**LEGAL ADVERTISEMENT
HISTORIC PRESERVATION BOARD
CITY OF PORTLAND
Public comments are taken at all meetings.**

**PUBLIC HEARING
ADA PANEL INSTALLATIONS AT CROSSWALKS**

**PUBLIC HEARING
394 DANFORTH STREET**

**WORKSHOP
80-86 EXCHANGE STREET**

SIDEWALK RAMP DETECTABLE WARNING PANEL

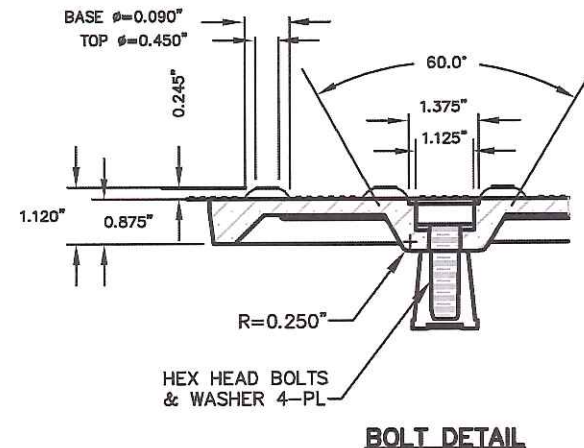
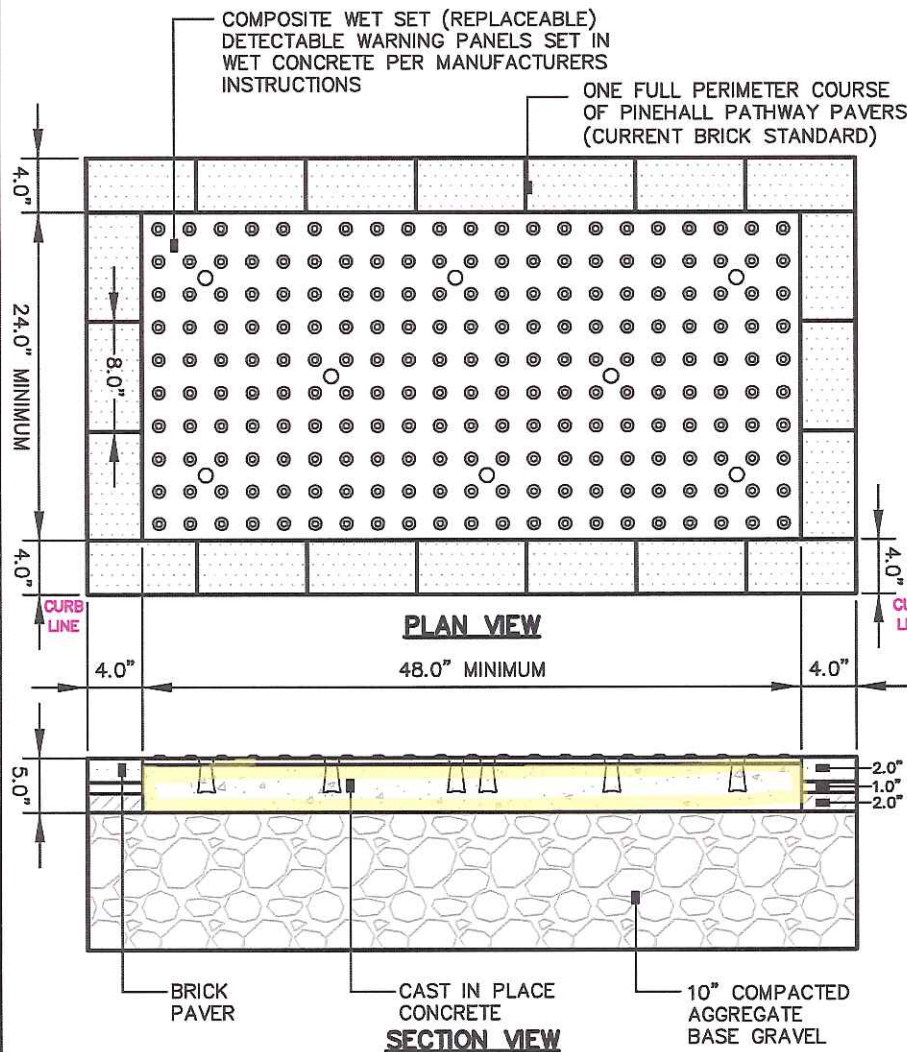
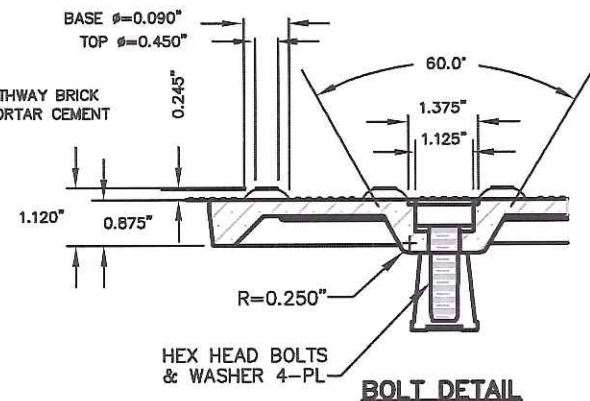
In light of recent composite detectable warning panel (DWP) failure around the City, Public Works is moving to the use of cast iron DWPs. Based on the way the cast iron panels are installed, we'd like to know if a visible concrete border between these panels and the surrounding brick would be acceptable in historic districts.

The reason for this request has to do with the points of contact on the back of the panels between the cast iron and the concrete. Most of the cast iron panels are designed to sit in concrete that comes all the way up the sides of the panel (this is the 4" concrete border you see in non-historic districts). If we replace the concrete next to the sides of the panels with brick, those panels will only be held in place by concrete from the bottom. This could potentially weaken the installation and lead to lose panels in the future. If concrete is acceptable around the panels, horizontal stability would be improved and we would be able to install panels consistent with manufacture specifications.

The two attached graphics highlight how the existing panels are held in concrete. Also attached is a simple copy of the installation instructions for Neenah Foundry DWPs.

1 GARAGE LEVEL
Scale: 1/4"=1'-0"

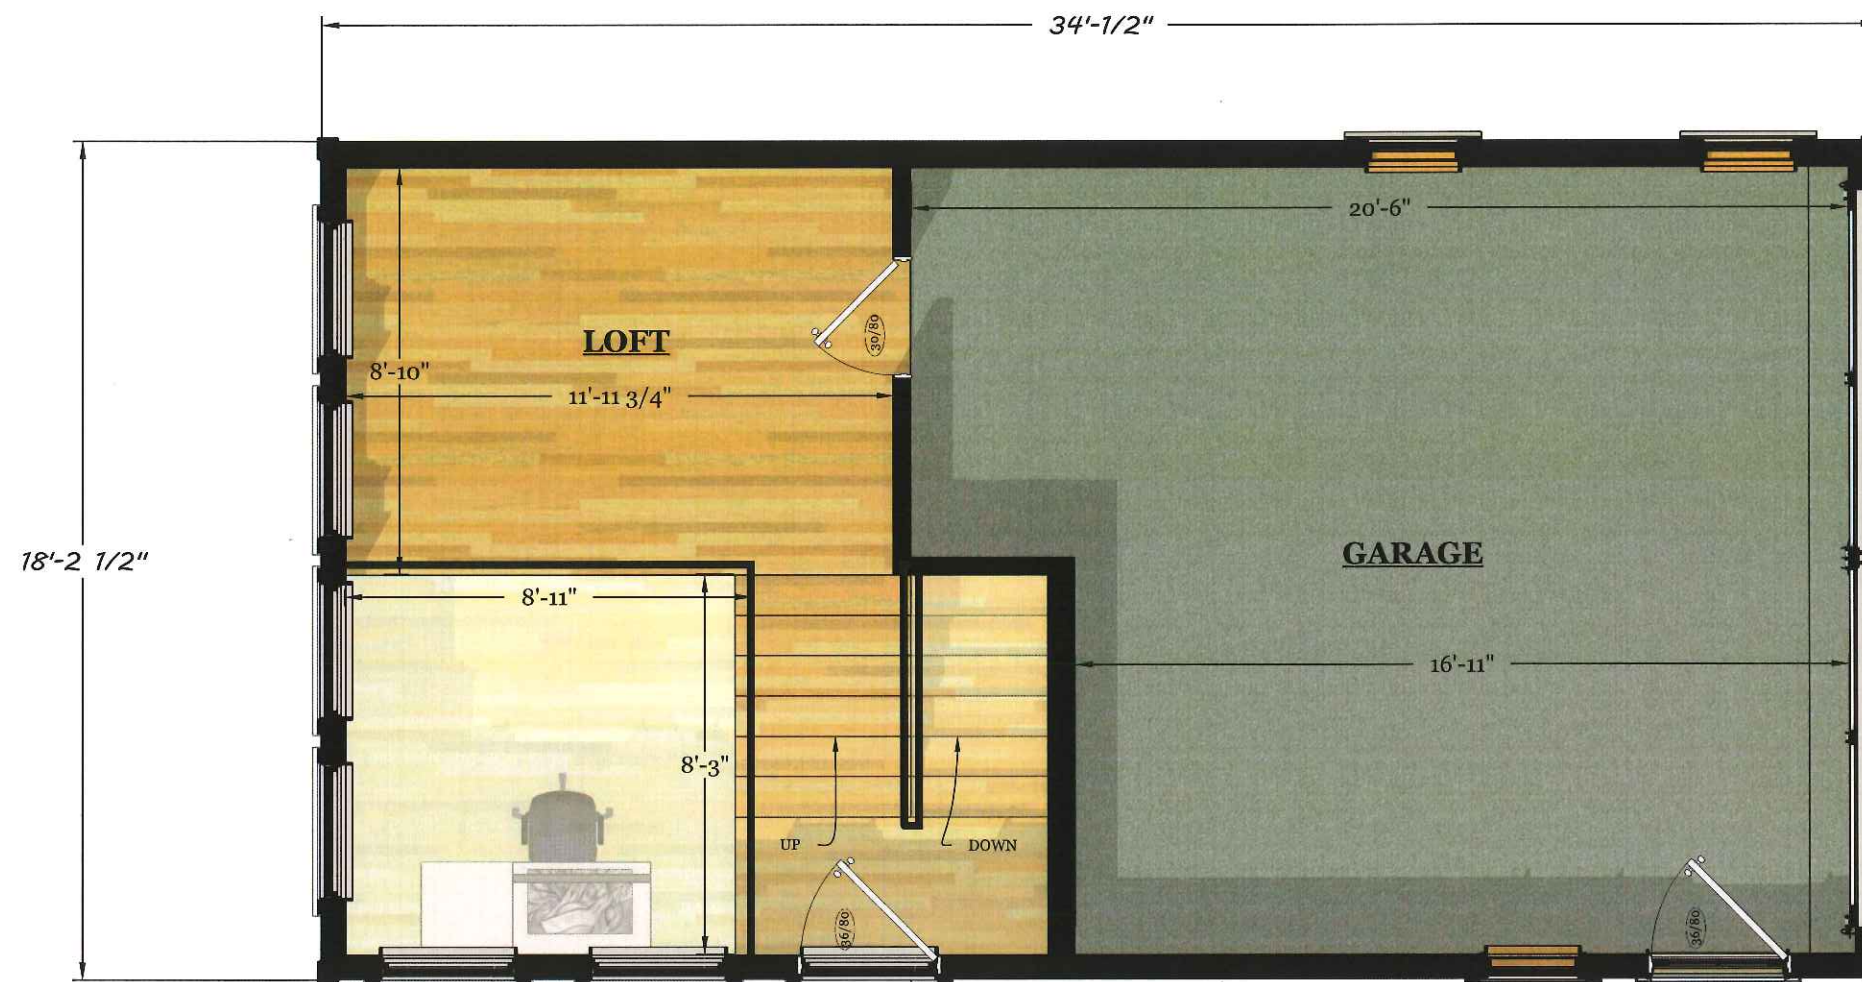
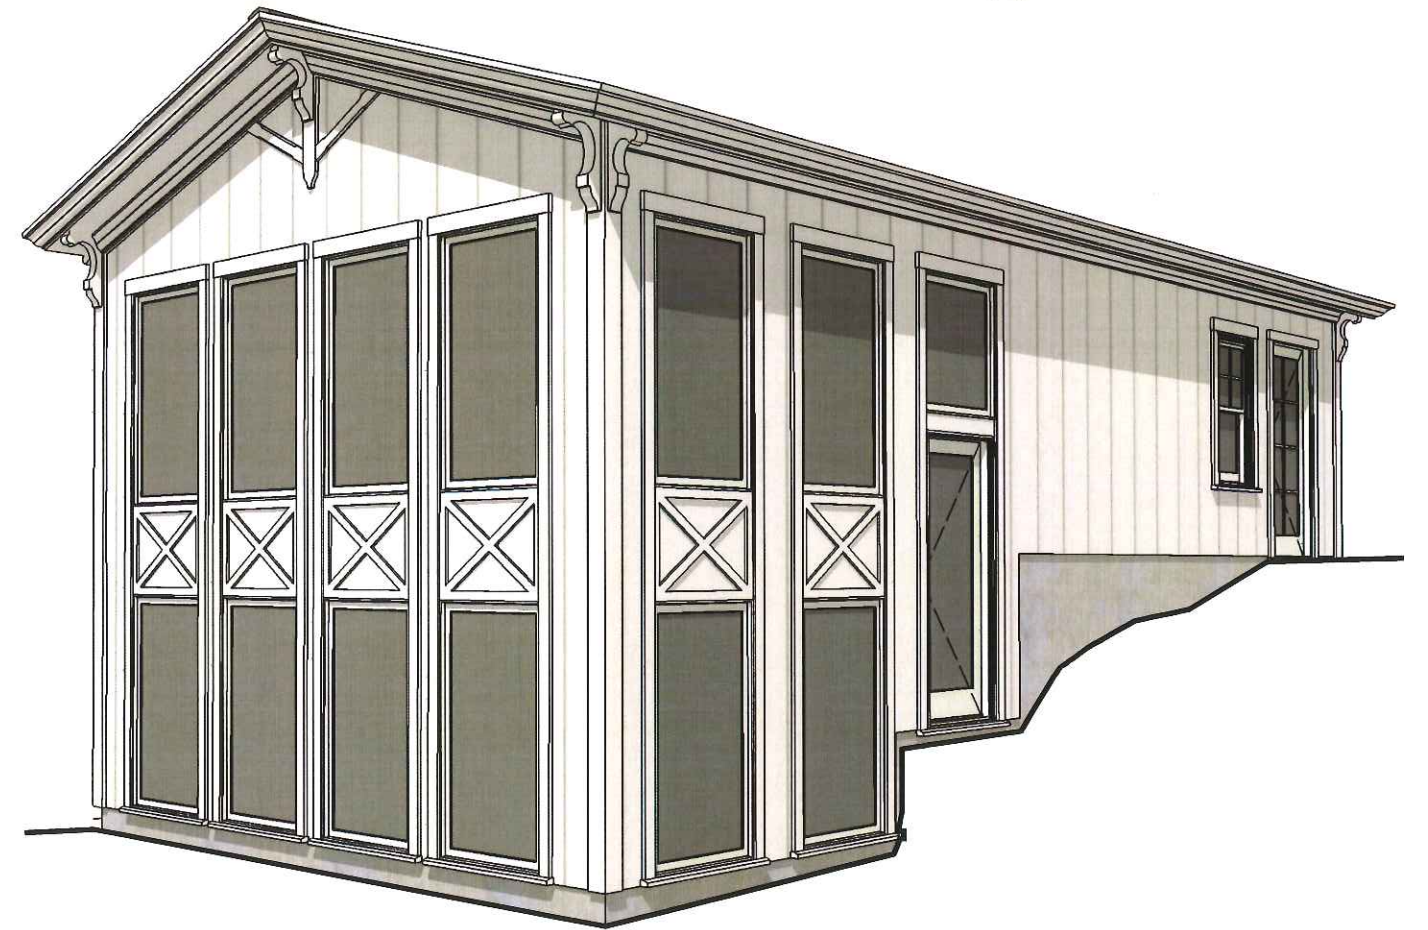
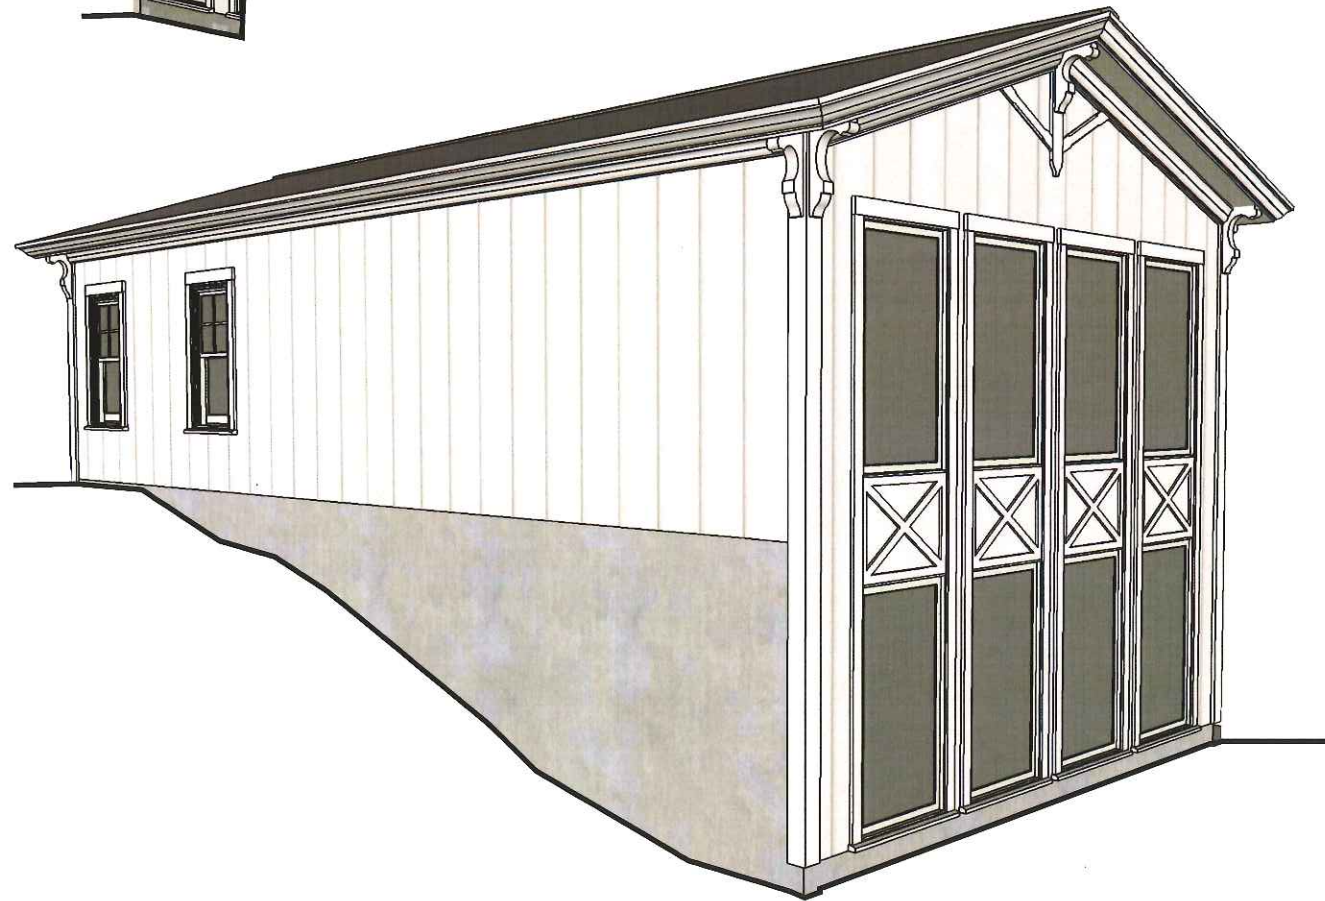
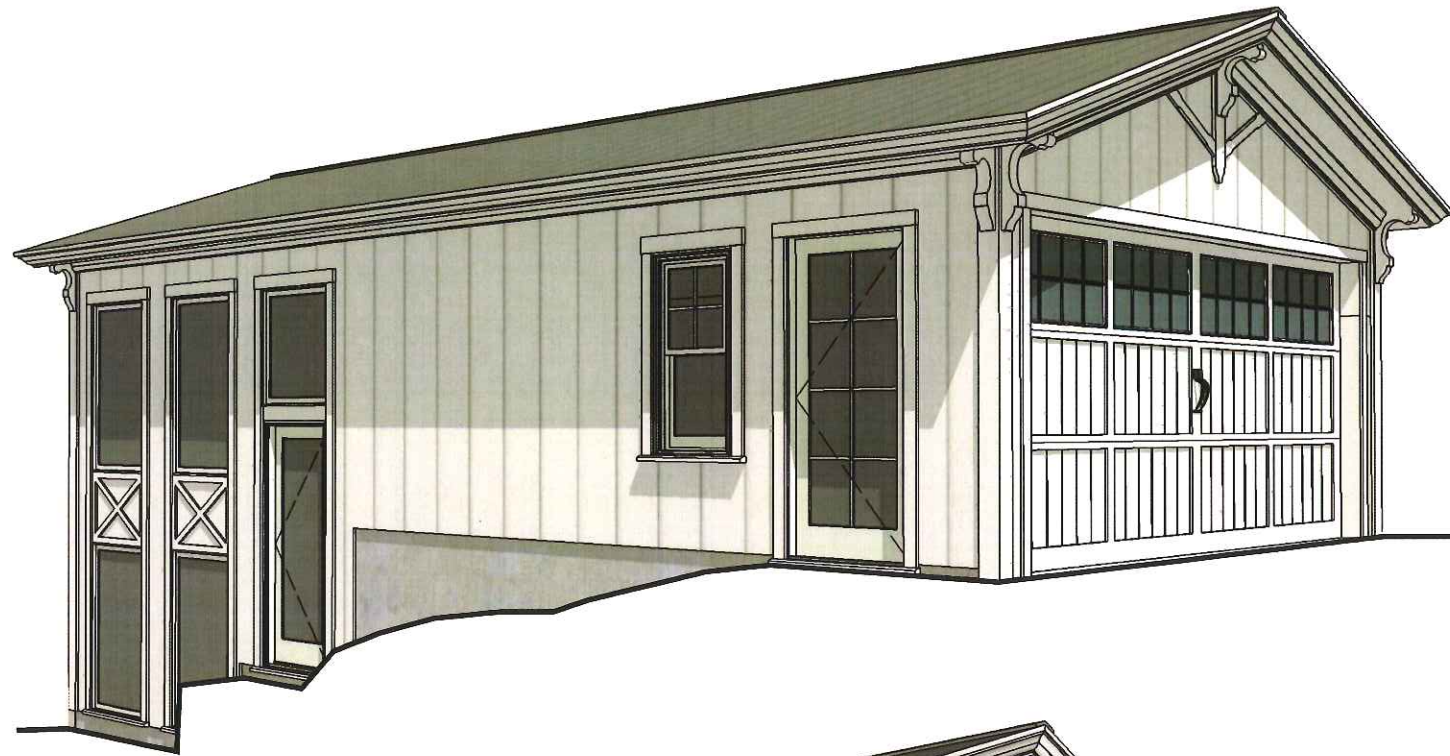
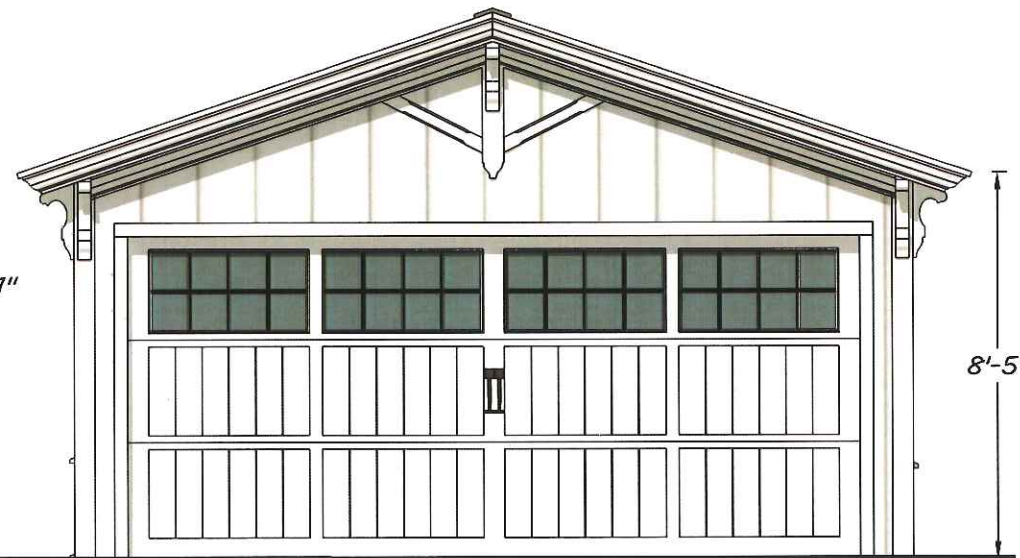
- The roof pitch has been lowered to a 4/12 pitch, with no lower pitched flare at the eaves
- The ridge height in the revised design has only decreased by an inch from the earlier plan (from 12'-0", it is now proposed at 11'-11", compared to the existing ridge height of 10'-5")

- The eave height has been raised by 5", to 8'-5" – see the comment below on the relationship between door headers and the roof / top-of-wall
- The eave height of the existing garage is shown as 9'-9" from the front grade, while the eave height in the preliminary design was 8'-0"

- Instead of slate, the siding on the front face is now proposed to be board-and-batten, consistent with siding proposed for the other three sides
- The garage door design has been simplified, with quieter rectangular frames surrounding panels of vertical flush boards.

- A slight adjustment has been made to the relationship between the tops of doors and windows and the eaves; this appears to be in response to a Board comment recommending more study of this relationship

The Board may wish to revisit the discussion of ridge and eave heights, and the relationship to wall and door height. At this time no detailed structural section drawings are provided, but no doubt Mr. Valliere's building profile reflects these considerations. As noted above, the eaves are proposed to be higher than they were depicted at the workshop, while the ridge height has not been reduced much since then. The desire to balance exterior appearance and massing with the creation of functional interior spaces is probably related to these decisions.
